<p>Addendum to Statement of Environmental Effects</p>
--

9 April 2019

**RE: Addendum to Concept Development Application Statement of Environmental Effects
189-197 Kent Street, Sydney (D/2018/1014)**

Figure 2 Proposed building envelope – Ground level plan

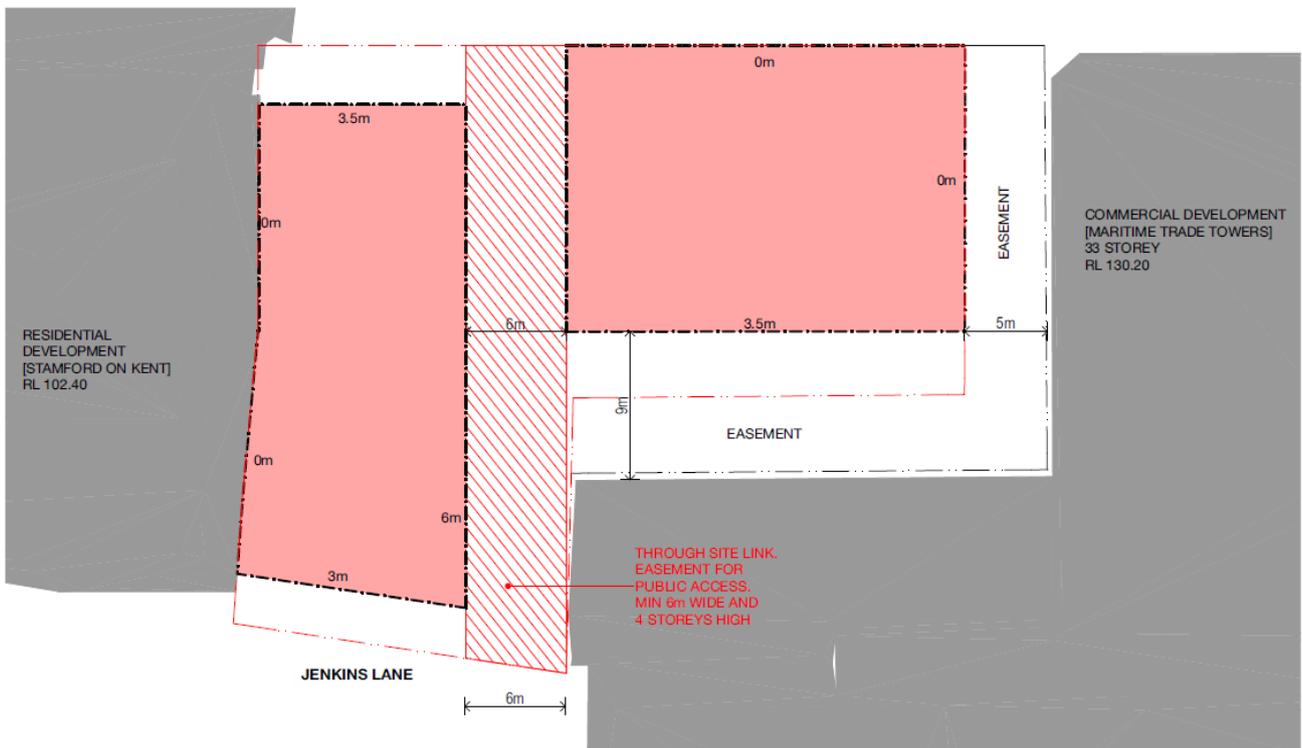
In response to comments made by the CSPC, the building envelope has been amended to include an east-west through site link as an easement for public access. The easement is 6m wide and 4-storeys tall, as shown in **Figures 2 - 3** below. Highly legible public access through the site was a key component of the competitive process winning scheme as identified by the selection panel.

Figure 3 Proposed building envelope – Kent Street elevation

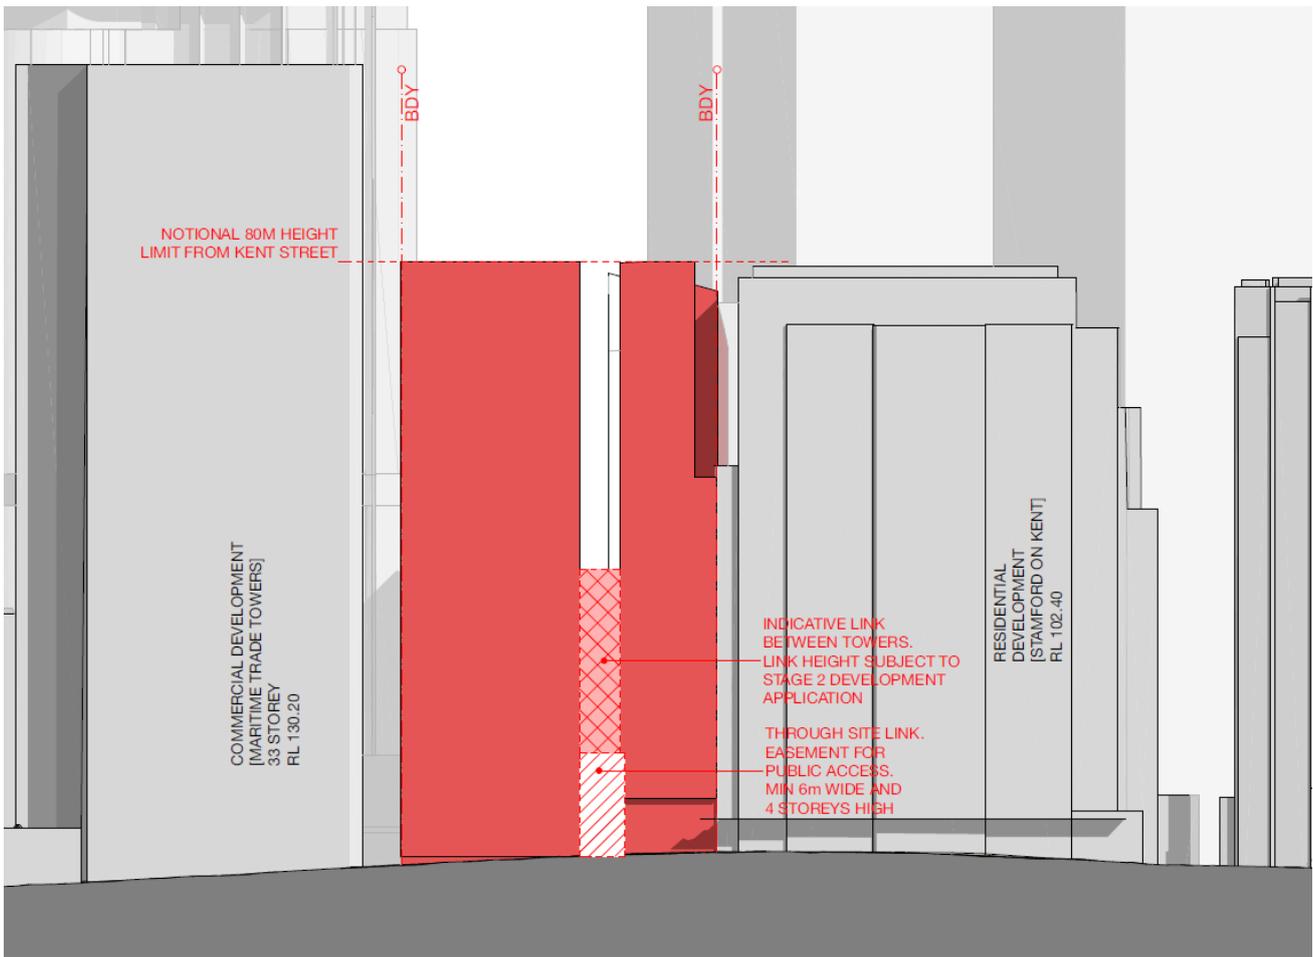
In order to reflect the FJMT competitive scheme and respond to comments made during the CSPC meeting around supporting a visual connection through to Barangaroo, the envelope has been amended to provide for two separated tower forms consistent with the indicative floor plans (refer to **Figure 3**).

Figure 5 Proposed building envelope – Typical tower level

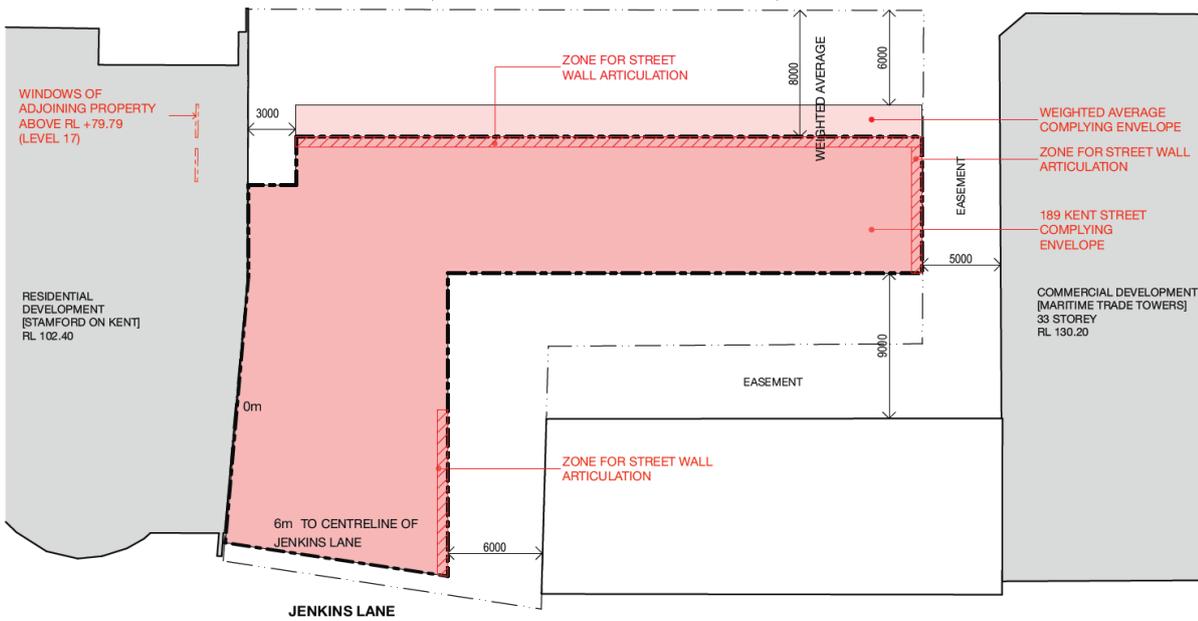
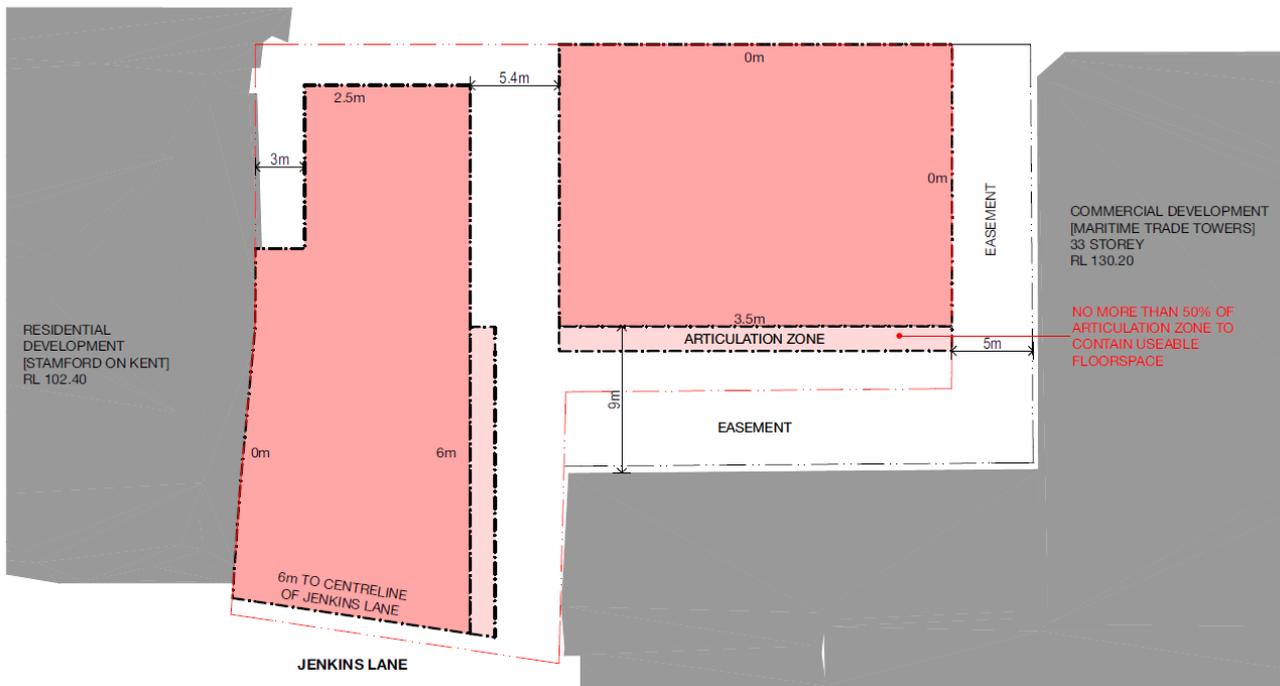
The southern tower massing provides a zero-setback, to align with the Maritime Trade Towers to the south. The northern tower massing provides a 2.5m setback to better align with Stamford on Kent to the north. **Figures 4 - 5** show a comparison between the envelope currently under assessment and the proposed envelope for a typical tower level.

Figure 7 Proposed building envelope – Kent Street perspective

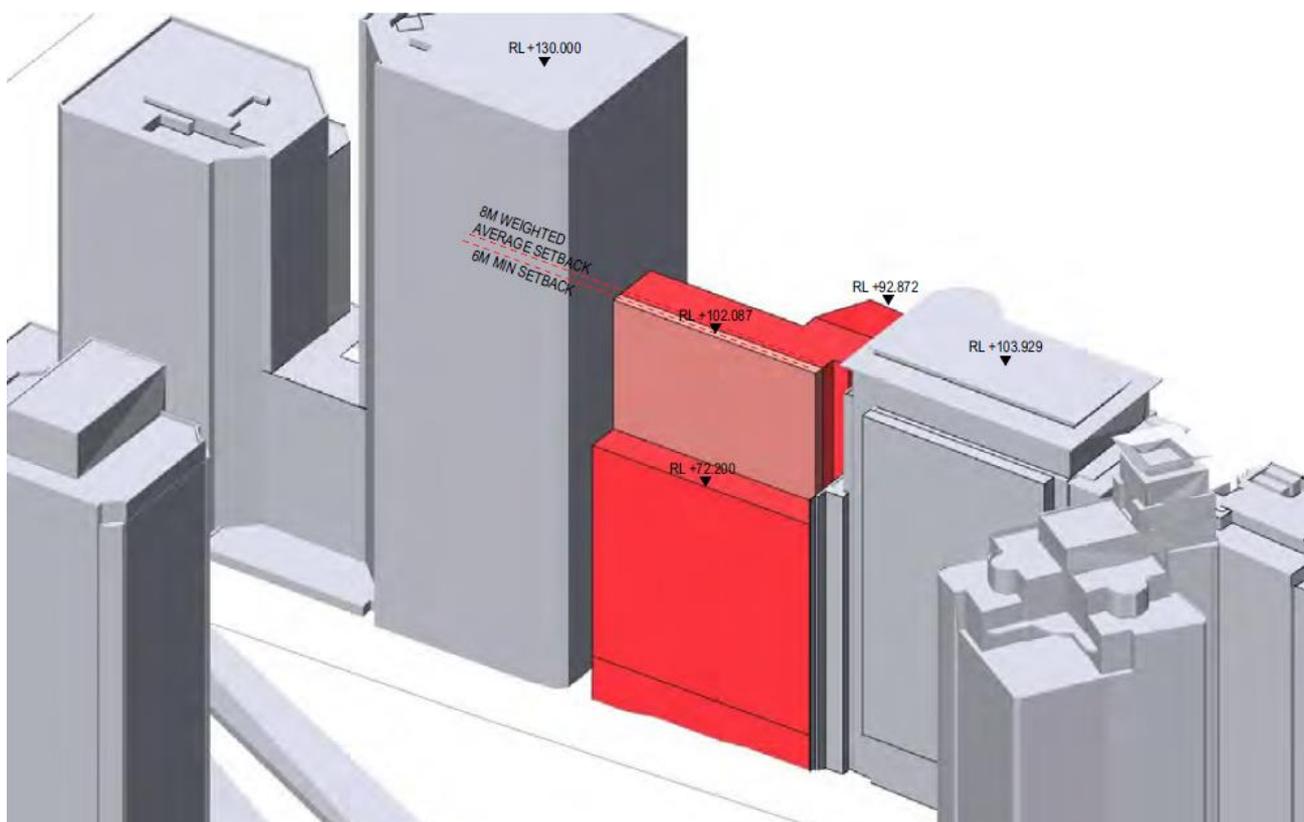
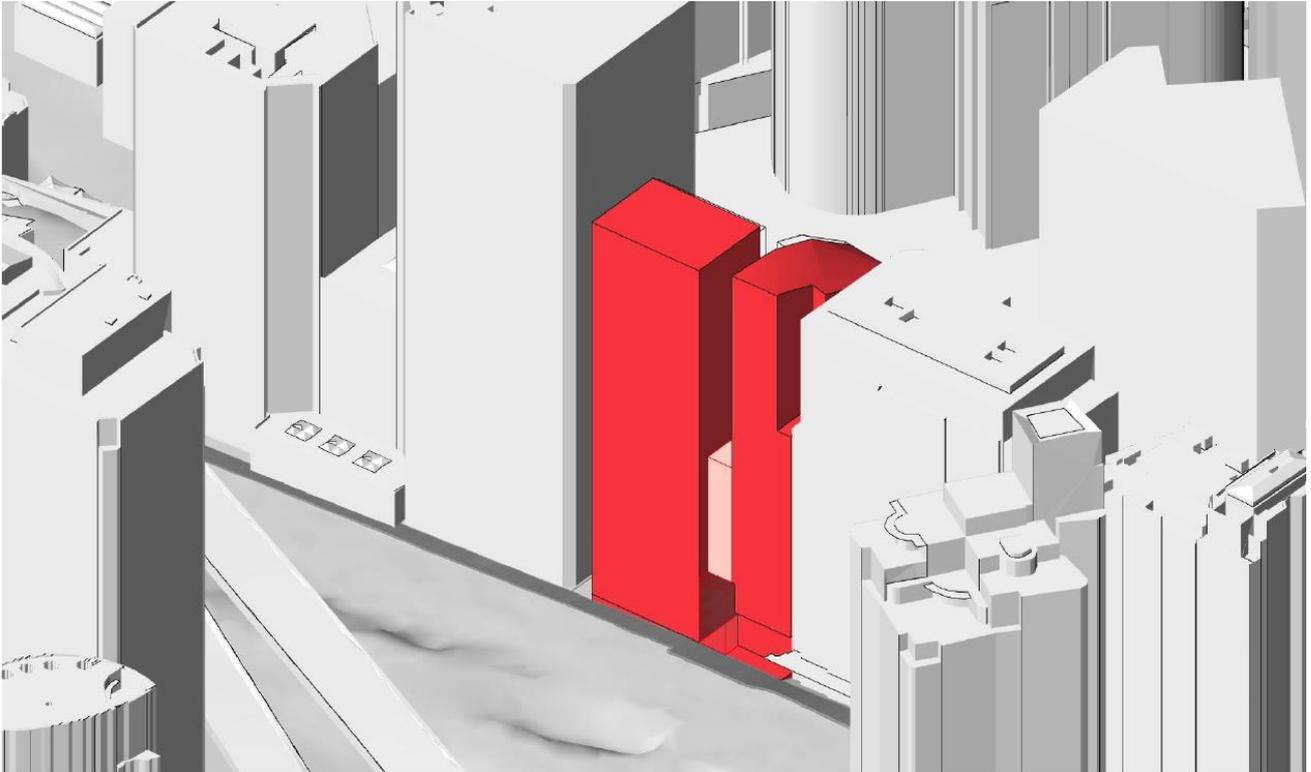
The amended envelope proposes no Kent Street tower setback above the podium. As shown in **Figure 6**, the envelope currently under assessment has a street wall height of RL 72.200. The removal of this street wall height in favour of a tower form that presents at street level was made in response to the existing streetscape of Kent Street surrounding the site. As shown in **Figures 6-7**, the existing buildings surrounding the site do not provide a podium street-wall with a tower setback. Hence the amended envelope provides a better response to the streetscape, as discussed further in **Section 4**.
